CITY OF WESTFIELD, IN
Advisory Planning Commission Meeting Agenda_10_17_2016

BOARD OR COMMISSION: Advisory Plan Commission (APC)

MEETING DATE: Monday, October 17, 2016 at 07:00 PM

Purpose: This document is an analysis by the City of Westfield Economic and Community Development Department of the proposed Wood Wind Planned Unit Development (PUD) District (1609-PUD-16) in review of the [2007 Westfield-Washington Township Comprehensive Plan](#).

Figure 1: Proposed Development Concept Plan

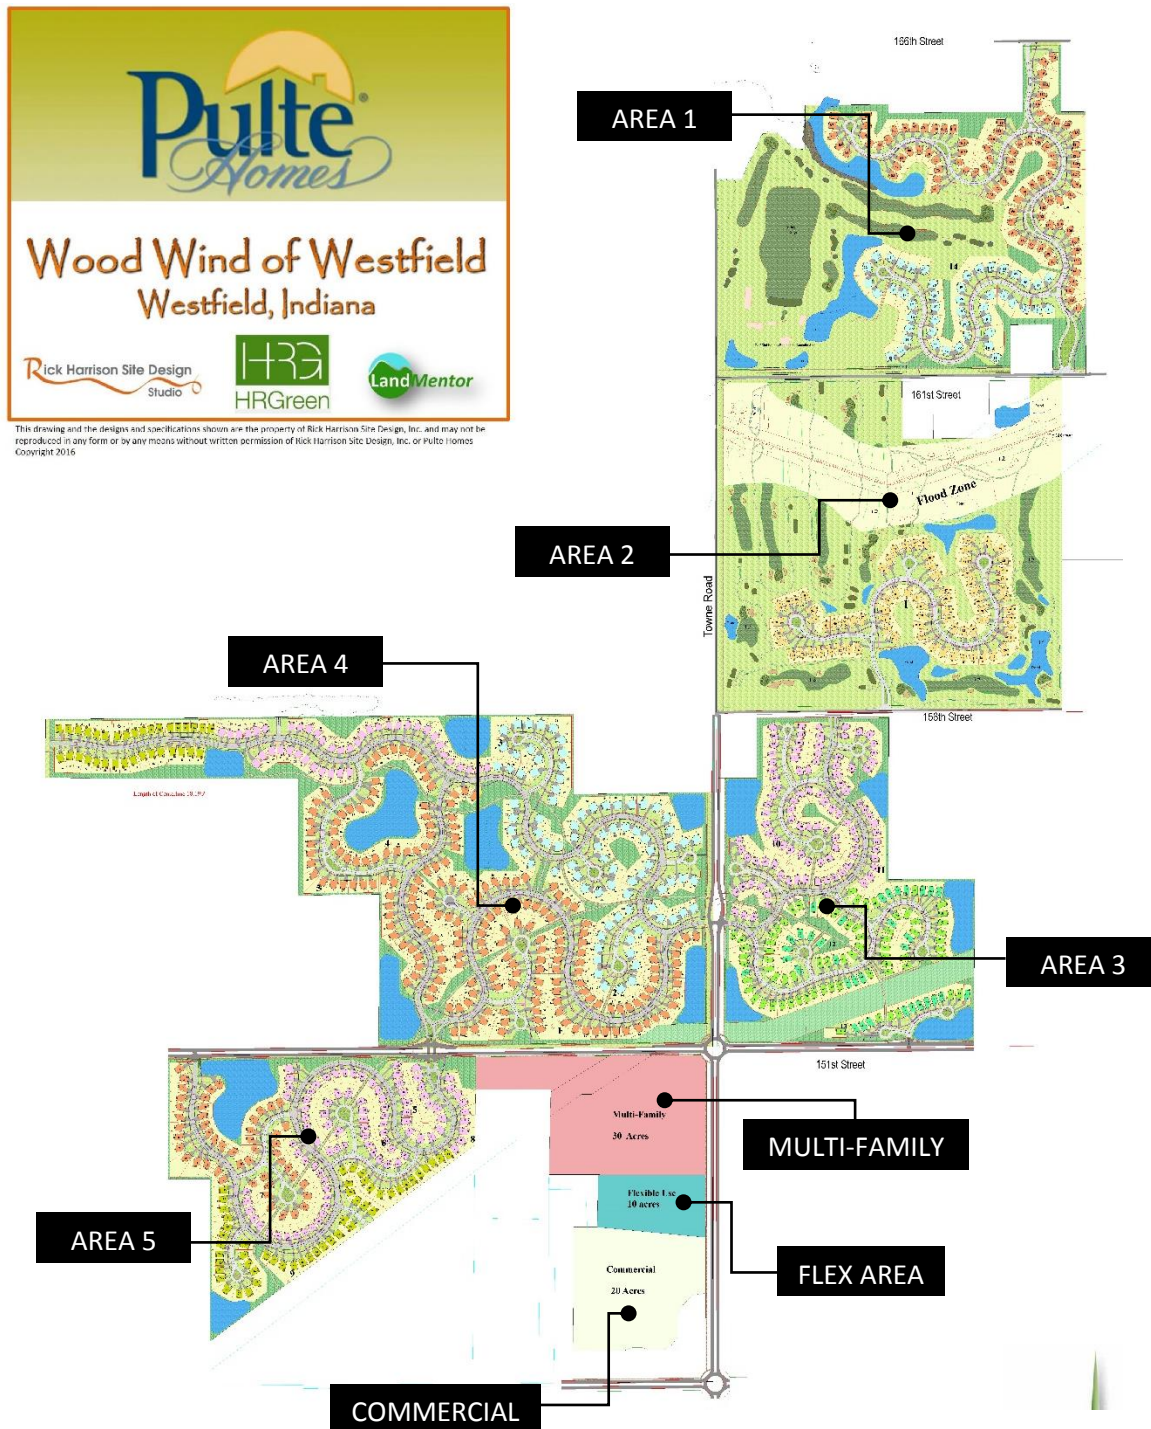
Buffers and Transitions (pg. 11)			
4	Provide appropriate buffers between the commercial development and any adjacent non-commercial uses, particularly residential uses.	✗	Proposed buffers are generally less than otherwise required by the UDO.
5	Use landscaped building setback areas to provide buffering from roadways.	✗	Proposed landscaping along perimeter streets is generally less than otherwise required by the UDO.
6	Where appropriate, encourage transitional land uses as buffers to help mitigate negative land use impacts. For example, attached housing could be used as a transition between commercial or industrial uses and single family uses. In addition to serving as a land use buffer, such housing can contribute to the goal of providing a balanced range of land uses. Attached housing should be used as a transitional land use only in coordination with actual commercial or industrial development. The mere presence of land recommended or zoned for future business uses should not be used as justification for attached housing as a transitional land use. Absent any existing or pending business use, any attached housing must stand on its own merits and not be justified as a transitional land use.	✓	Without consideration to landscape buffering, the proposed development incorporates land use transitions. For example as the proposed development transitions north from 146 th Street to 151 st Street, the commercial uses transition to attached residential uses and the proposed density of the single-family uses of Area 5 (2.48 du/acre +/-) transitions from 146 th Street corridor to the other single-family uses north of 151 st Street.

7	Provide appropriate transition between adjacent dissimilar residential areas.	✗	Proposed buffers are generally less than otherwise required by the UDO.
8	Ensure proper buffering between existing residences and new development of a dissimilar character.	✗	See other development policies herein (#4, #44, #58, #68, #83) regarding transitioning/buffering commercial uses, suburban uses and rural uses.
9	Develop a range of buffering requirements, to allow for different buffers in different situations.	✗	
10	Combine “hardscape” buffers, such as fences and walls, with landscaping and distance for a more pleasing aesthetic effect.	✓	Entry monuments and perimeter landscaping along streets incorporate rural stone and horse fencing.
11	Utilize natural open space for buffering in industrial areas.	--	Not applicable; no industrial areas.
12	Encourage the use of natural buffers involving “reforestation” of natural vegetation, particularly when buffering between suburban and rural uses, and between existing uses and new development.	✗	Proposed development includes natural buffers, but are generally less than otherwise required by the UDO and they do not include elements of reforestation.

13	Discourage the use of berms for buffering.	✓	Berms are not proposed.
Connectivity (pg. 12)			
14	Provide pedestrian systems within open space and along roadways to connect to surrounding pedestrian and bicycle networks, particularly the Midland Trace and Monon Trails.	?	An insufficient level of detail on the Concept Plan is available to determine whether this policy would be met.
15	Avoid fragmentation of open space into isolated, unconnected areas, except to provide passive recreation, neighborhood parks and commons.	✗	With the scale and level of detail on the Concept Plan, the proposed open spaces appear isolated with limited connectivity.
16	Link spaces within neighborhoods and between neighborhoods and the larger community through a multi-modal system of fully connected routes to all destinations.	?	An insufficient level of detail on the Concept Plan is available to determine whether this policy would be met.

17	Include pedestrian facilities in all new developments. In particular, develop improved connections between key destinations such as between residential and commercial areas, and between residences, parks and schools.	?	An insufficient level of detail on the Concept Plan is available to determine whether this policy would be met; however, the Department has provided specific comments to the petitioner to comply with the UDO's connectivity requirement that if incorporated, would likely result in this policy being achieved.
18	Participate in regional transportation efforts that promote better regional connectivity, such as the IndyGo Bus service.	--	Not applicable for this location.
Contiguity of Development (pg. 14)			
19	Encourage new development to be located contiguous to existing development. In rare circumstances, non-contiguous development may be permitted when it is vital to the economically and spatially efficient expansion and improvement of key infrastructure.	✓	The proposed development is contiguous with approved and pending developments, which include (see Figure 2): Towne West PUD (approved), Liberty Ridge (proposed), Harmony PUD (under development), West Rail PUD (under development), Ackerson Farms PUD (approved), Westgate PUD (approved), Bent Creek (under development).

31	Locate open space so as to maintain the visual character of scenic roads.	?	<i>The concept plan generally appears to satisfies this policy; however, where back yards are adjacent, the perimeter landscaping is generally less than required by the UDO.</i> <i>The petitioner is also proposing to modify the UDO's perimeter architectural standards and the proposed ordinance does not specify increased setback requirements from perimeter streets.</i>
32	Require open space in all new developments. Open spaces should consist of usable areas or valuable natural areas. Open space should not consist only of land that is left over in the site plan review process.	?	<i>Aside from the central amenity area in the northeast area of the proposed development and with the scale and level of detail on the Concept Plan, the other proposed open spaces appear limited and isolated with limited connectivity.</i>
33	Preserve natural features such as stands of trees, water bodies, and wetlands when land is developed.	?	<i>Please see other policies herein (#30).</i>

Figure 3: Future Land Use Concept Map

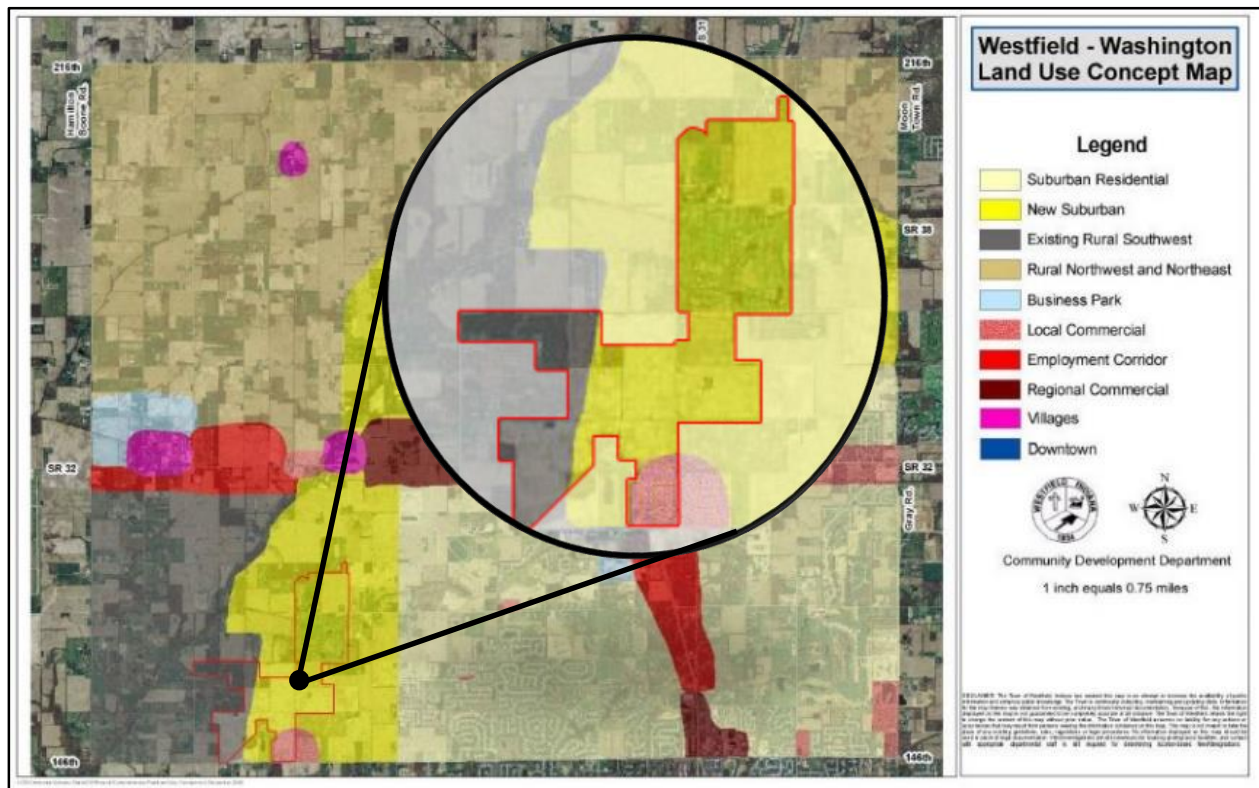
DEVELOPMENT POLICY		REVIEW COMMENTS	
Existing Rural Southwest: Development Policies (pg. 27)			
41	View large-scale commodity farms (crops and livestock) as being subject to eventual change under growth pressure. Washington Township is in the path of growth and it is expected that the few remaining large-scale agricultural tracts will be converted to other uses. [Limit the land uses to those that are consistent with and contribute to the rural character.] [Housing in this district is secondary to the agricultural and equestrian uses.]	?	This policy acknowledges that development is likely and anticipated; however, this area (Areas 4 and 5) of the proposed development and the corresponding density do not appear to contribute to the rural character.
42	Encourage artisan farms and equestrian uses to maintain the rural, country-like atmosphere.	--	
43	Protect and enhance the Eagle Creek Trail as a recreational amenity.	--	The proposed development does not abut the Little Eagle Creek corridor.

44	Allow the continuation of the historic rural patterns (single-family houses on large parcels). New residential development will be accommodated, but only on large lots consistent with existing patterns or in Rural or Conservation Subdivisions as defined in this plan. [Establish maximum densities aimed at retaining rural character and maintaining the existing density.]	x	This area also includes the proposed development's highest single-family density concentrations of approximately 2.5 du/acre. The proposed development should generally fall within, or at a minimum should transition to, the desired character of the Existing Rural Southwest area, as it transitions from the commercial node and higher intensity uses of the 146 th Street corridor. See other policies herein regarding desired preservation of environmental features (#30, #33).

Figure 5: New Suburban Area

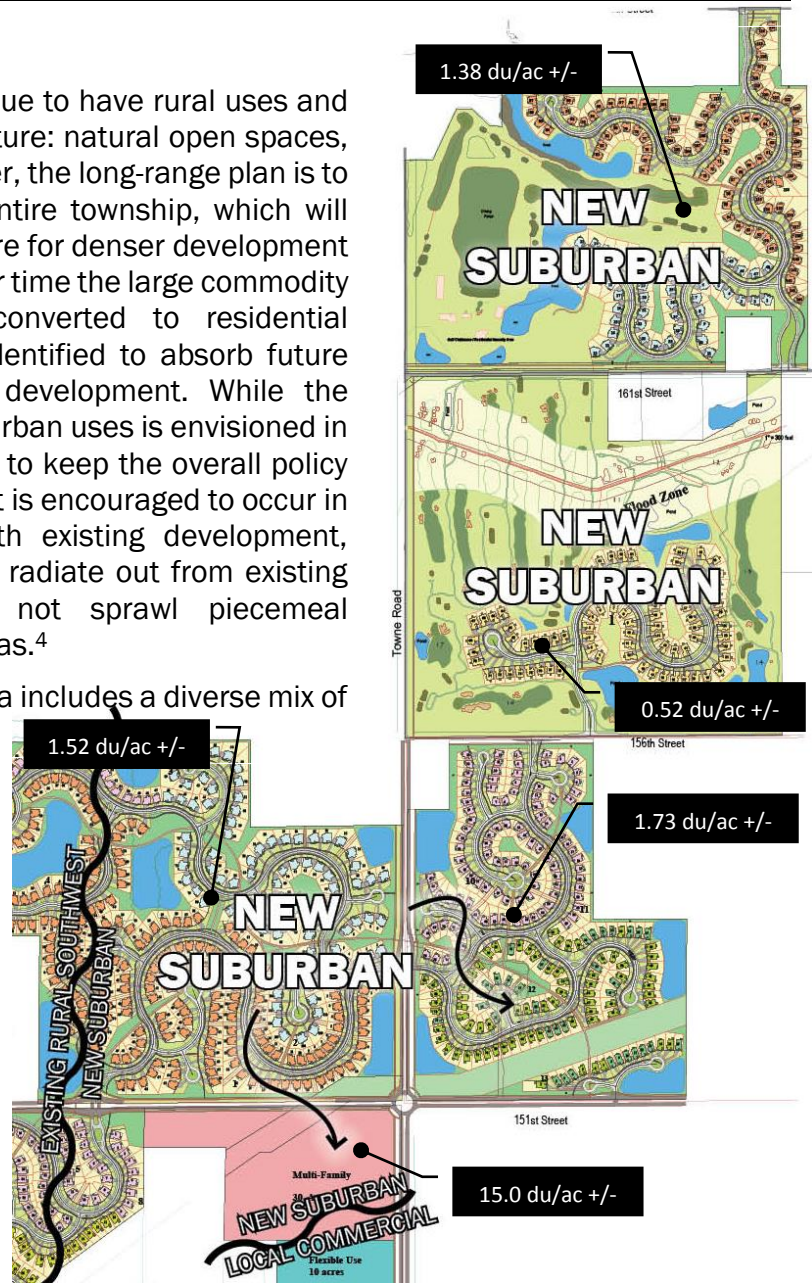
55	Encourage a diverse range of home styles in individual subdivisions, using innovative architecture of a character appropriate to Westfield.	?	
56	Encourage compatible and high quality "life span" housing in furtherance of the overall policy of this plan. [Establish appropriate locations for varying housing types.]	✓	Please see overarching policies (#1).
57	Emphasize connectivity between subdivisions, and avoid creating isolated islands of development.	?	As proposed, the Concept Plan does not embrace this policy; however, the Department has provided specific comments to the petitioner to comply with the UDO's connectivity requirement that if incorporated, would result in this policy being achieved.
58	Ensure proper land use transitions between dissimilar types of residential development.	✗	Please see overarching policies (#7).
59	Ensure appropriate transitions from businesses located along US 31, SR 32, and SR 38 and from adjoining large subdivisions.	—	Does not apply.

60	Use open space, parks, and less-intensive land uses as buffers in appropriate circumstances.	?	Proposed buffers are generally less than otherwise required by the UDO. Ponds are generally located around the perimeter of the proposed development as a buffer transition.
61	Preserve existing older structures when possible.	✓	The proposed development embraces the existing golf course structures. The remainder of the real estate generally consists of properties that do not include existing structures.
62	Permit new development only where the transportation network is sufficient for the added traffic volumes. Based upon traffic studies, developers should make appropriate improvements to mitigate traffic impacts resulting from the new development.	✓	Please see overarching policies (#38-40).
63	Promote flexible design that maximizes open space preservation by regulating density rather than lot size. This approach permits a wide range of lot dimensions (area, frontage, setbacks, etc.) and a variety of housing types (detached, semi-detached, attached) to serve multiple markets (traditional families, single-parent households, empty-nesters, etc.). [Emphasize density, rather than lot size.]	?	Please see overarching policies (#24-37).

69	Locate roadways and house lots so as to respect natural features and to maximize exposure of lots to open space (directly abutting or across the street). "Single-loaded" streets (with homes on one side only) can be used to maximize open space visibility, thus increasing real estate values and sales, while costing no more than streets in conventional subdivisions (due to savings from narrower lot frontages).	?	Please see overarching policies (#29-37).
70	Encourage attractive streetscapes that minimize front-loading garages, provide garage setbacks from front facades of houses, minimize design and material repetition, and avoid house orientations where the back sides face the public right of way.	x	The proposed ordinance does not restrict front load garages and setback requirements for front load garages, nor does it establish architectural standards.
71	Encourage roadway improvements that promote safety but do not increase speed.	✓	The curvilinear design of the proposed development is a recognized method to calm traffic speeds.
